# HYUNDAI

## Technical Service Bulletin

GROUP	NUMBER
<b>CAMPAIGN</b>	<b>20-01-010H</b>
DATE	MODEL(S)
<b>February, 2020</b>	<b>2020MY KONA</b>

**SUBJECT:** 2020MY KONA OS GROSS AXLE WEIGHT RATING (GAWR) CERTIFICATION LABEL REPLACEMENT (RECALL CAMPAIGN 187)

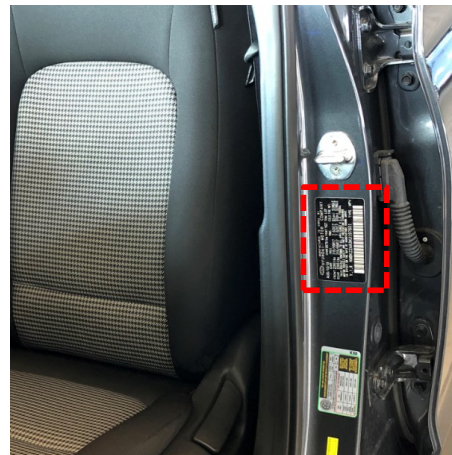
**Description:** Certain 2020 model year Kona vehicles indicate the incorrect Gross Axle Weight Rating (GAWR). As such, these vehicles do not comply with Federal Motor Vehicle Safety Standards. An incorrect GAWR could result in the vehicle being overloaded, increasing the risk of a crash. This bulletin describes the procedure to replace the affected area of the GAWR certification label.

1. Open the driver's side door and locate the GAWR certification label located just below the B pillar door latch.

2. Ensure the existing GAWR certification label is clean and dry. If necessary wipe with a clean water dampened rag and dry the label off.

3. Put the updated GAWR label over the portion of the existing GAWR label.

Completely place the updated GAWR label straight so it does not cover any other information on the existing label.
